**TOWN OF BAY HARBOR ISLANDS
DEVELOPMENT & REVIEW COMMITTEE MEETING
THURSDAY, MARCH 9, 2023**

Subject: Site Development Plan Application – Revision - #2 DRC Review
9110 West Bay Harbor Drive - Multi-Family Residences (9 DU)
Bay Harbor Islands Acct. No.: SPR22-000032
MMPA Acct. No. 01-0702-1130C

**Town of Bay Harbor Islands
Development Review Committee (DRC) Staff Report - #2 DRC Review
9110 West Bay Harbor Drive - Multifamily Residential Development (9 DU)
Site Development Plan Application - Revision
March 3rd, 2023
Page 2**

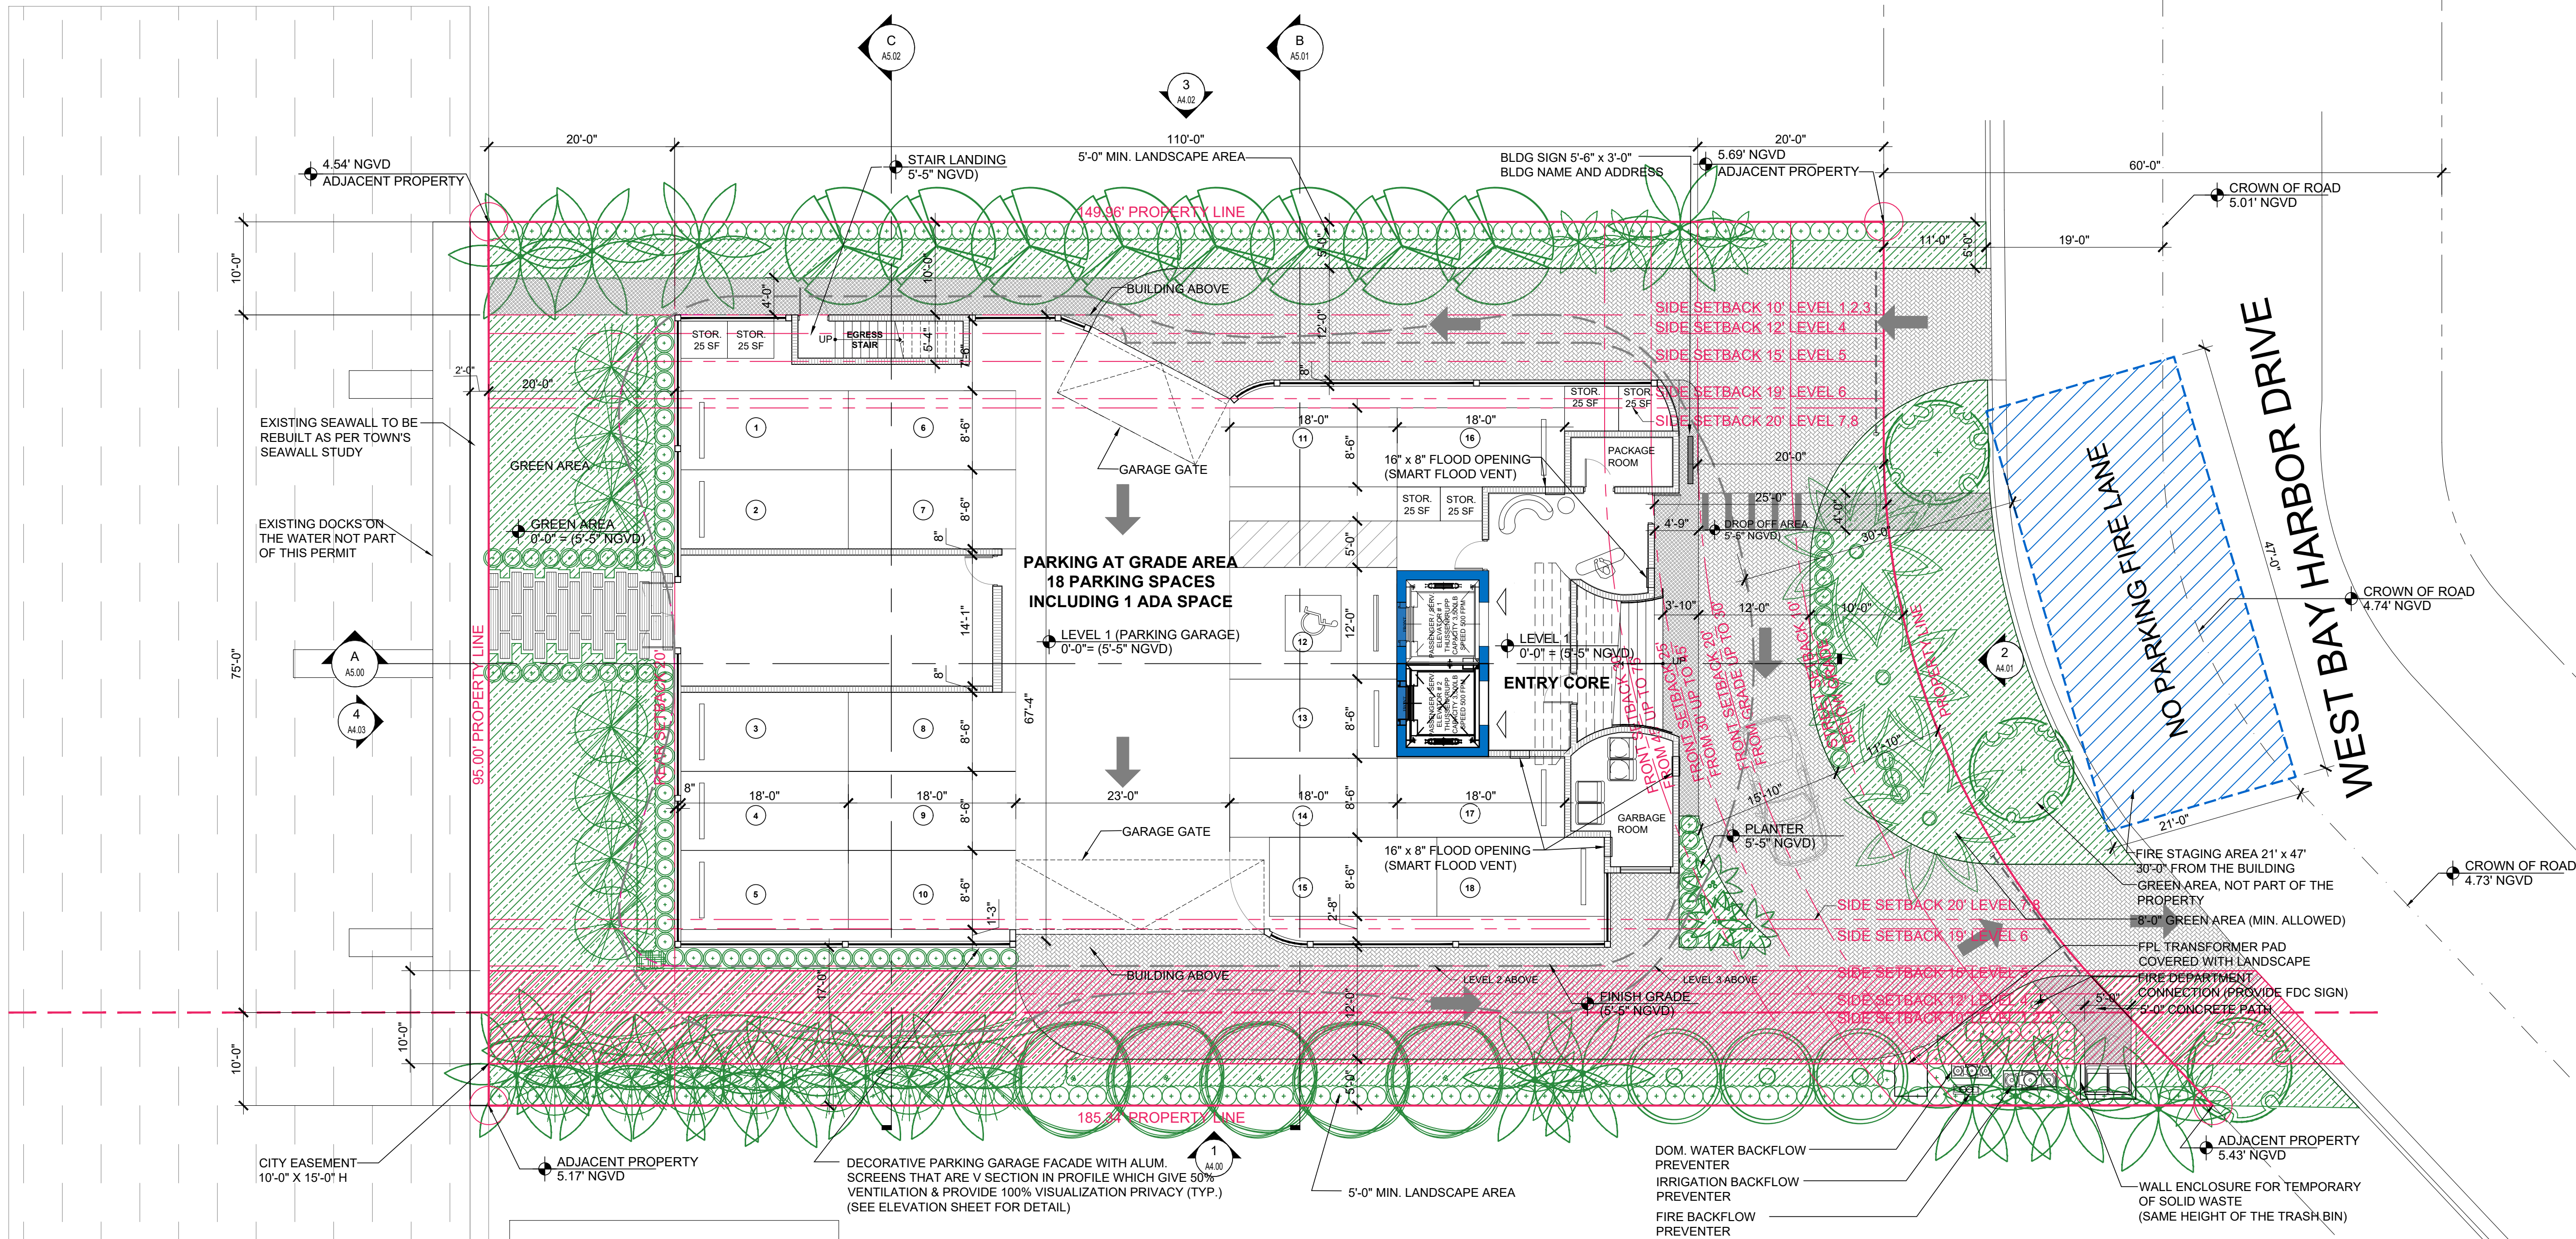
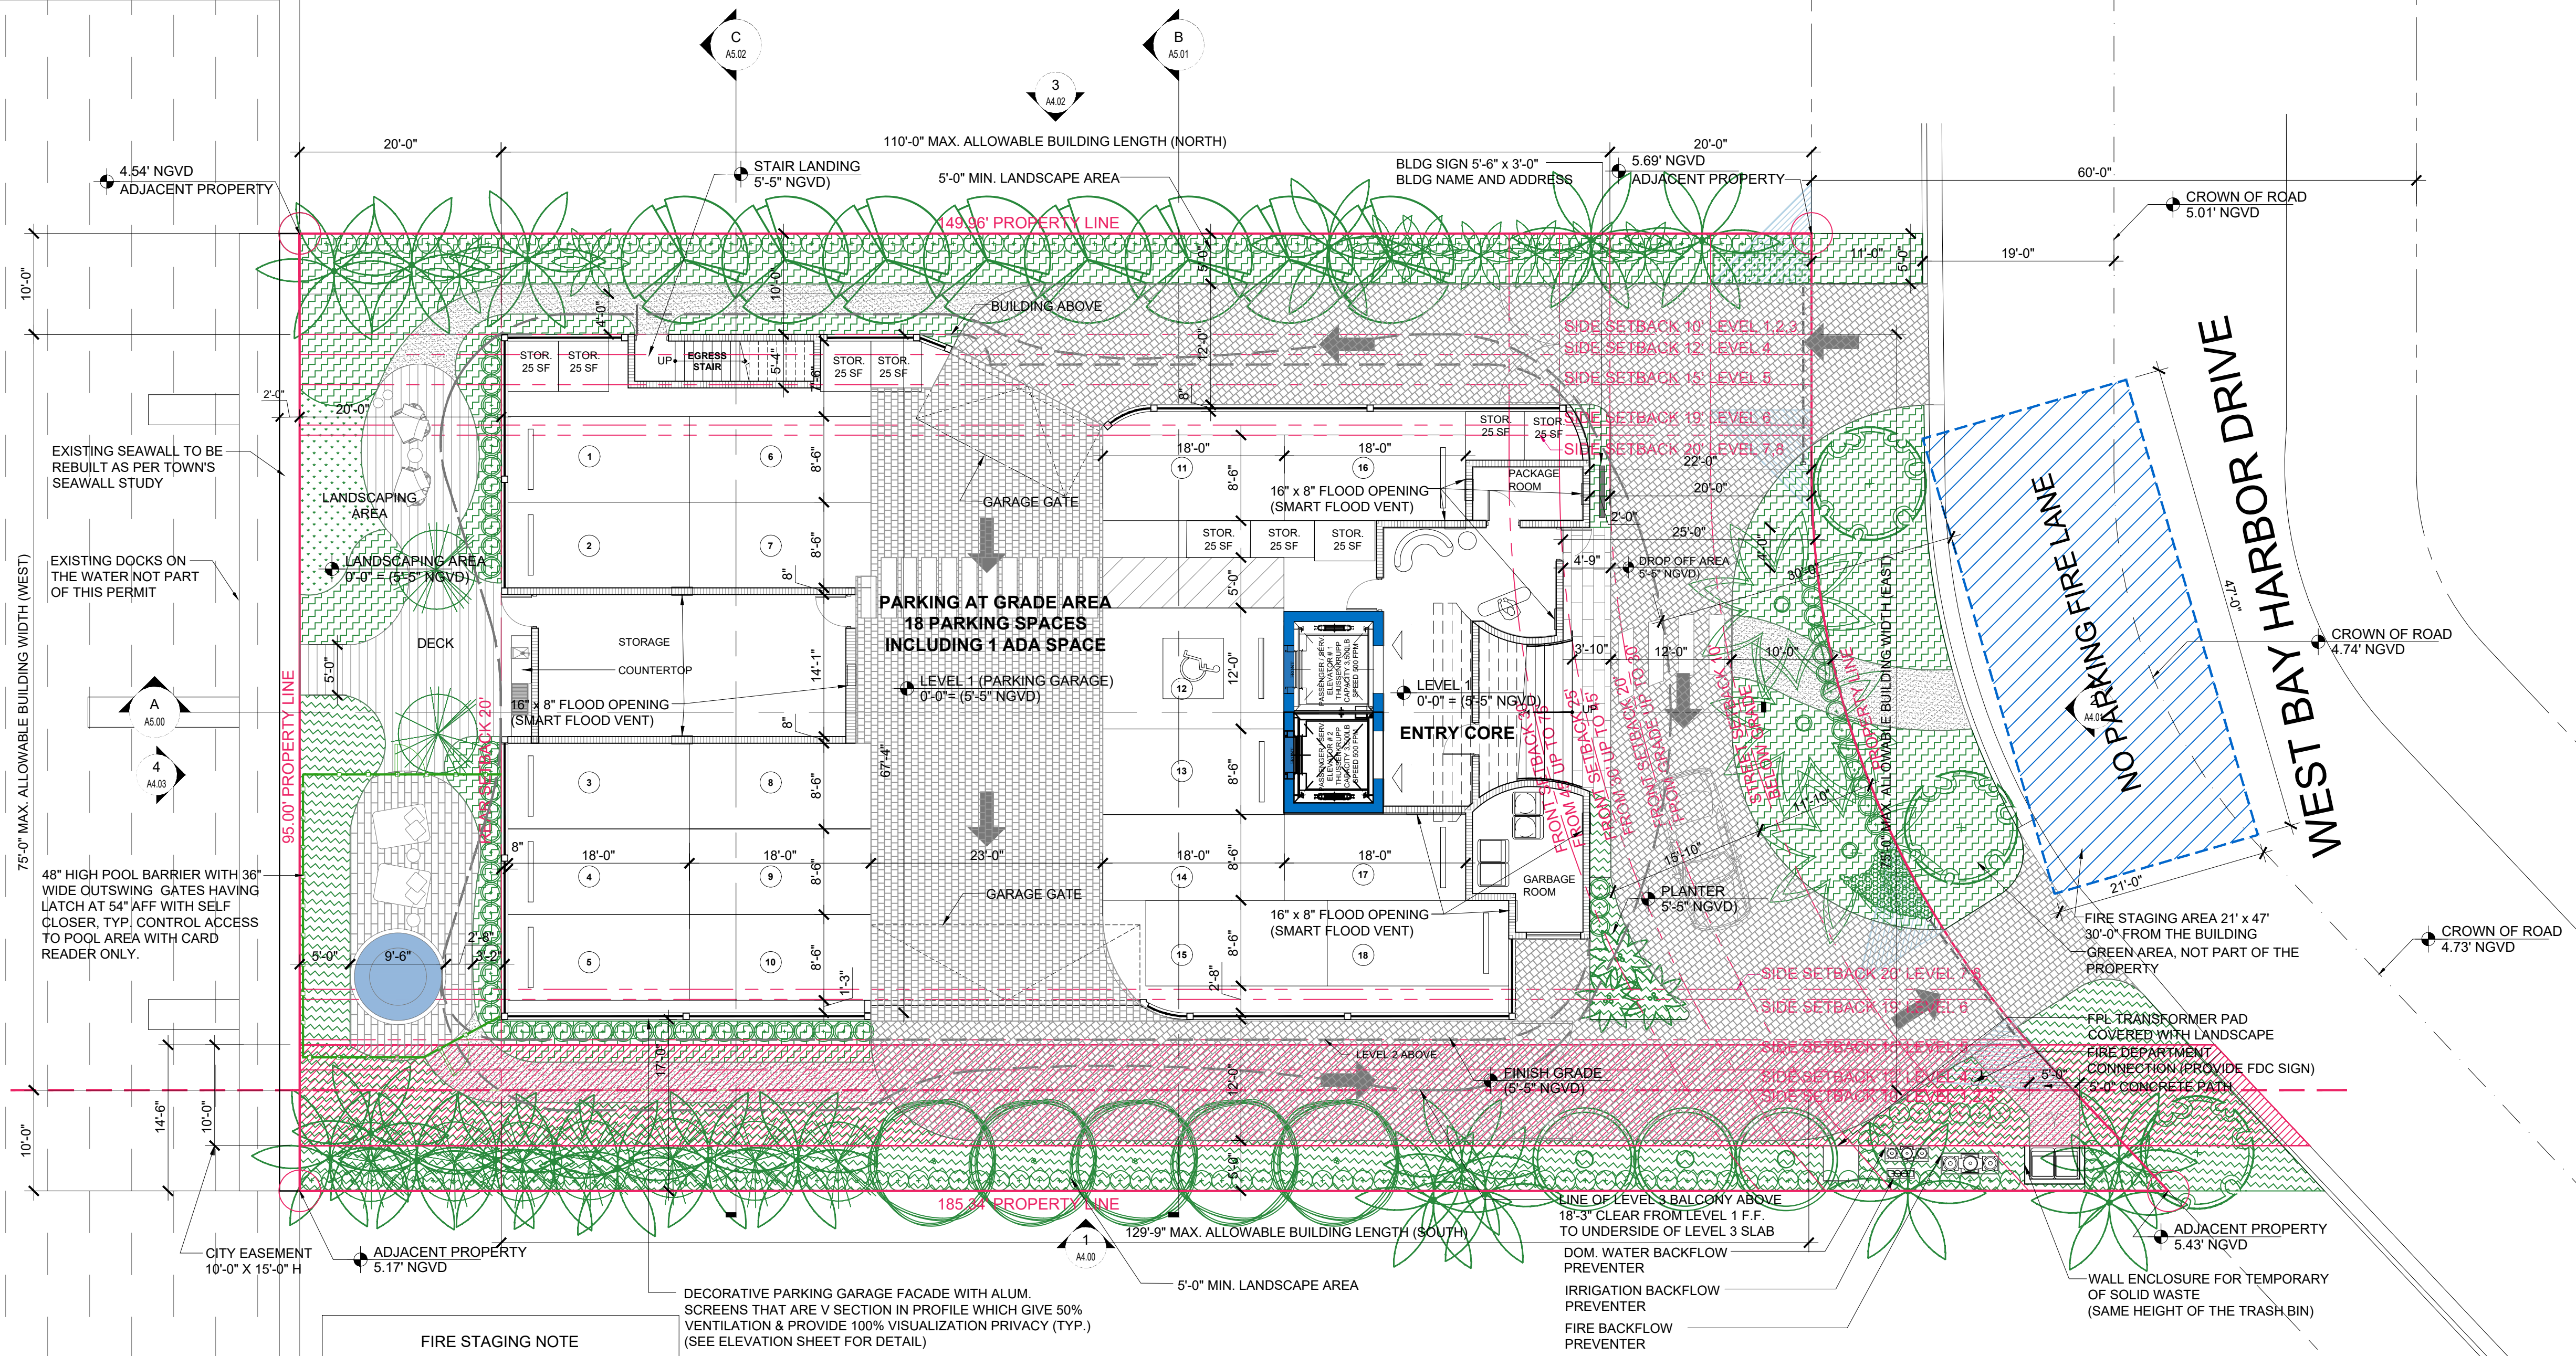
One Fire Department staging area is shown on the plans. The applicant should meet with the Miami-Dade County Fire Department staff as soon as possible to verify the proposed staging area, as this may affect the site design. The proposed Fire Truck staging area is shown in the paved roadway area fronting the subject site. It may not be located in the swale as that area is required for drainage / streetscape landscaping.

FLOOR PLAN - LEVEL 1

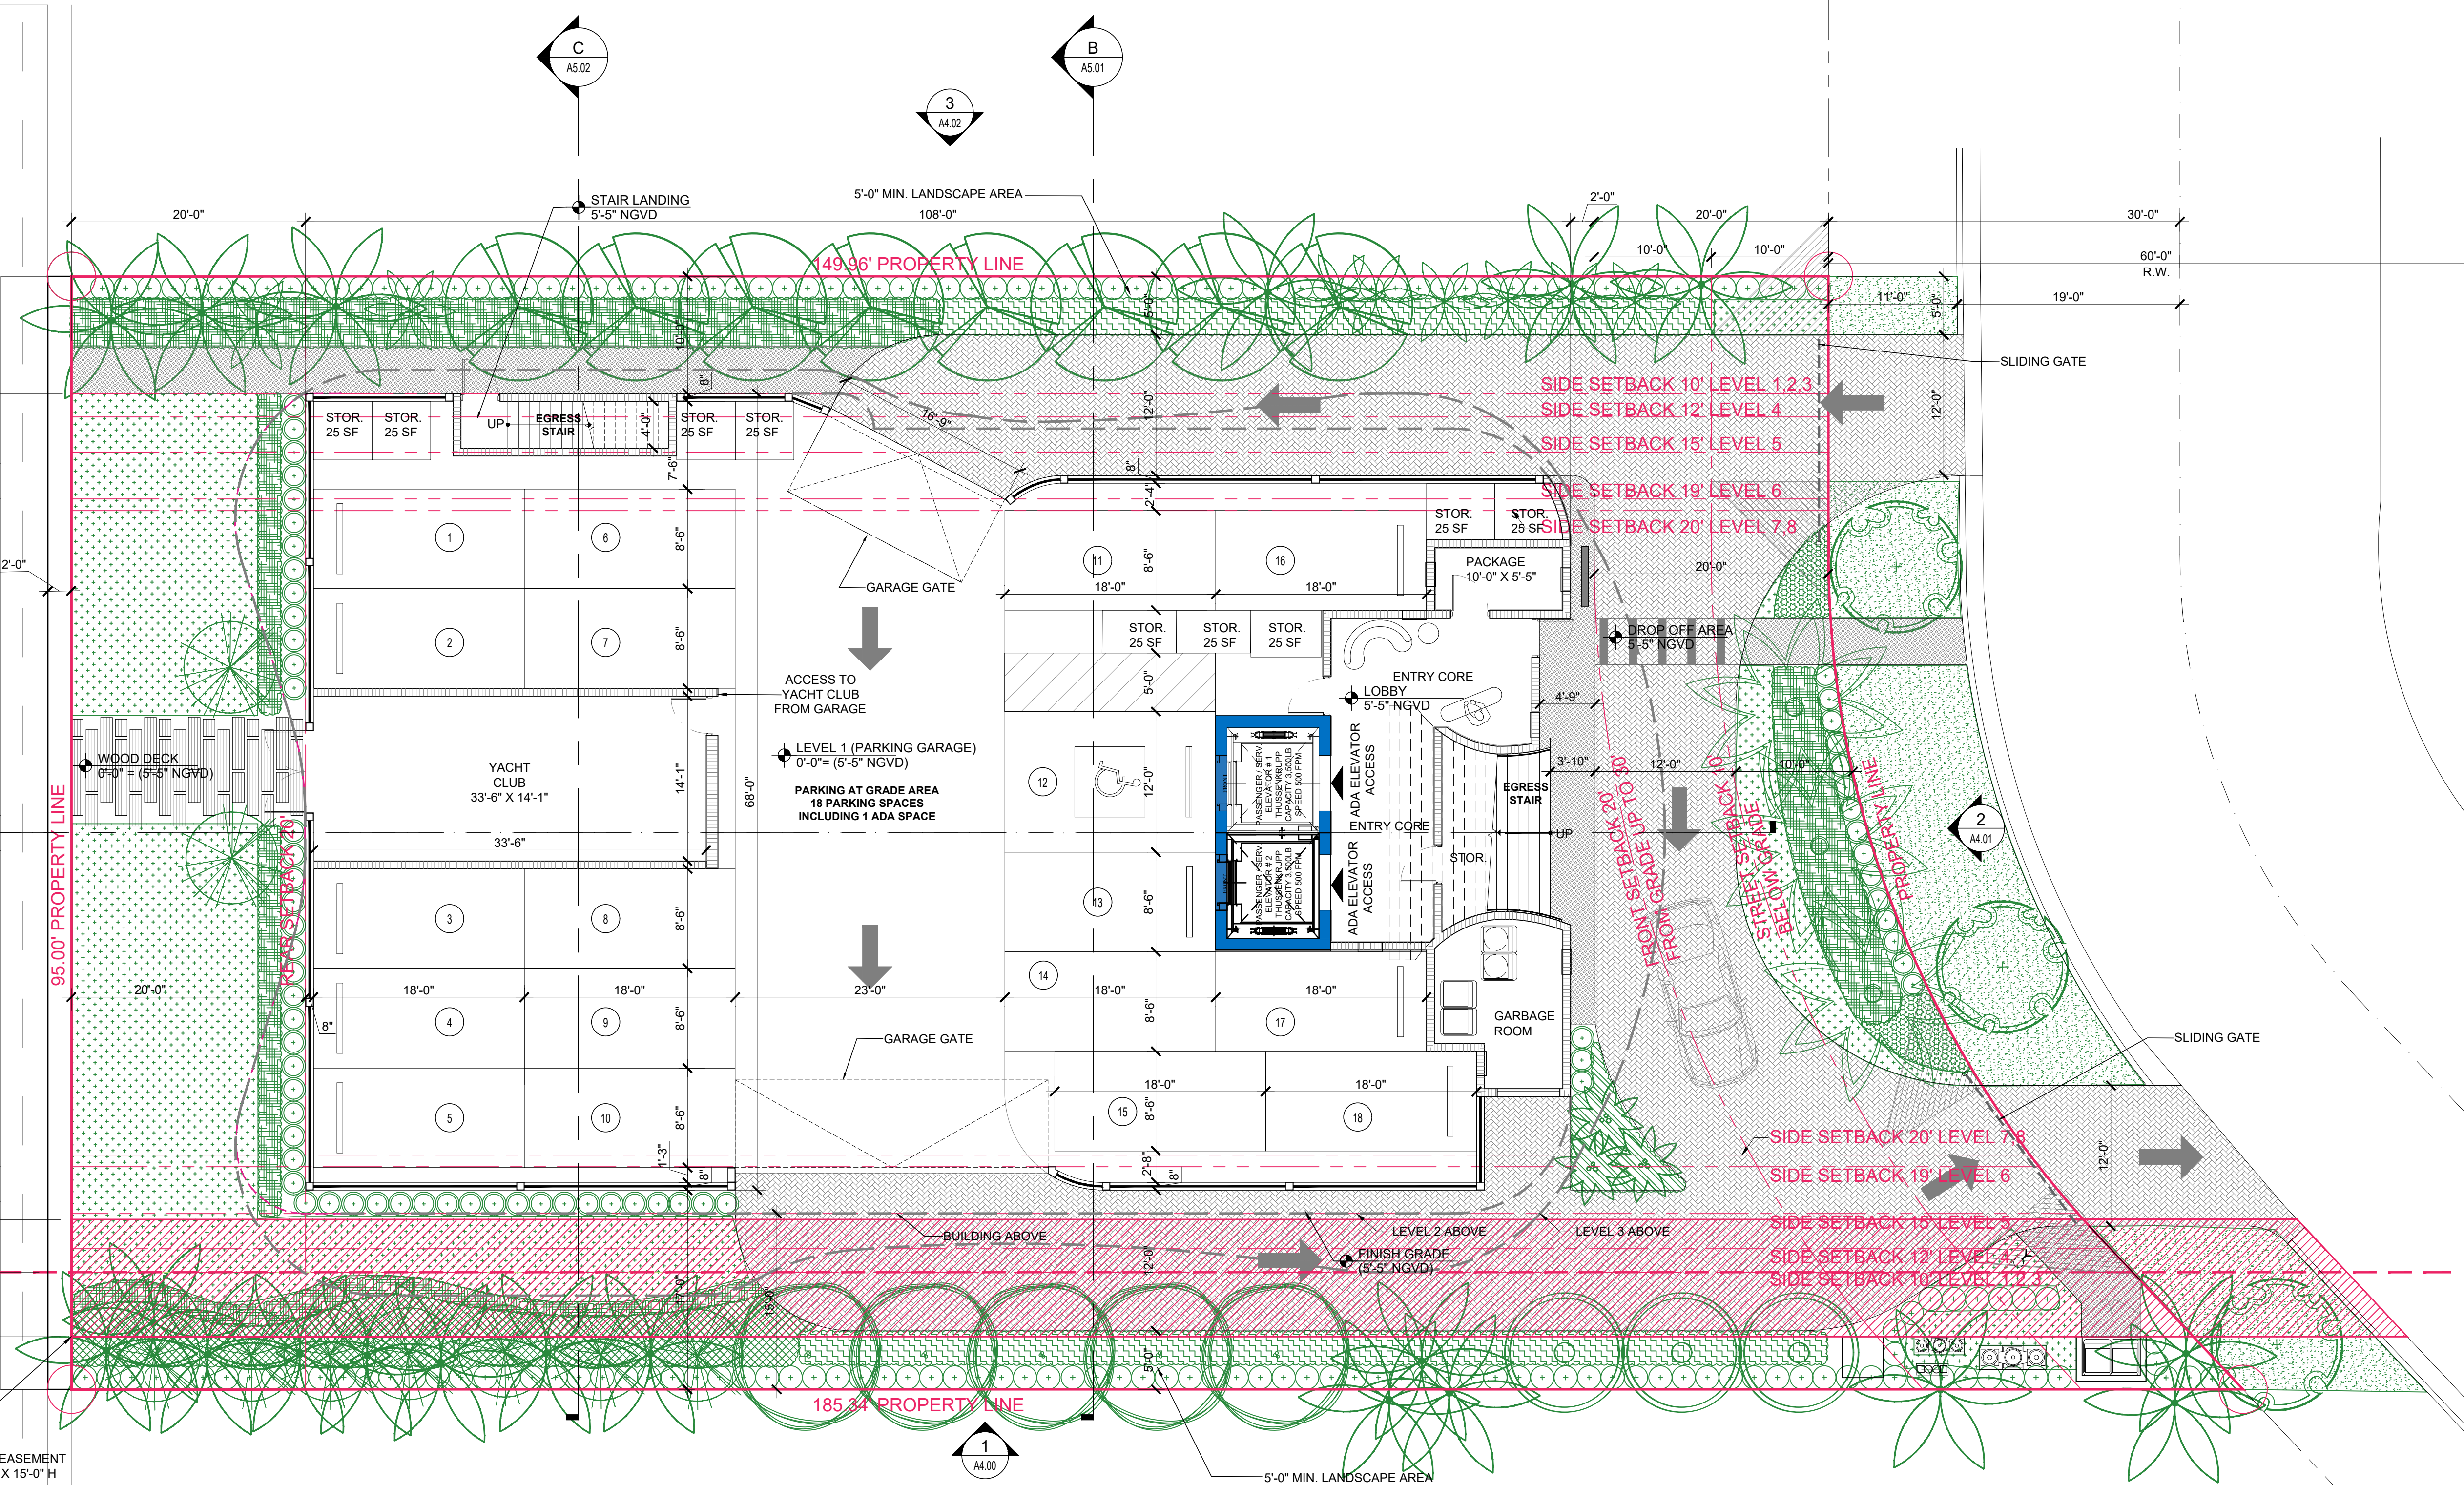
- 3) On Level One the original plans showed a so-called "Yacht Club". The DRC questioned what that was - it was explained it was primarily for storage for boat owners. The Bldg. Official explained the area could not be habitable, as it would need to comply with FEMA / FBC flood elevation requirements. Since the floor elevation is below BFE this would not be possible. The plans were revised to add a notation "Storage". MMPA will include a condition of approval in the DRB report limiting the use of this area to only "storage".
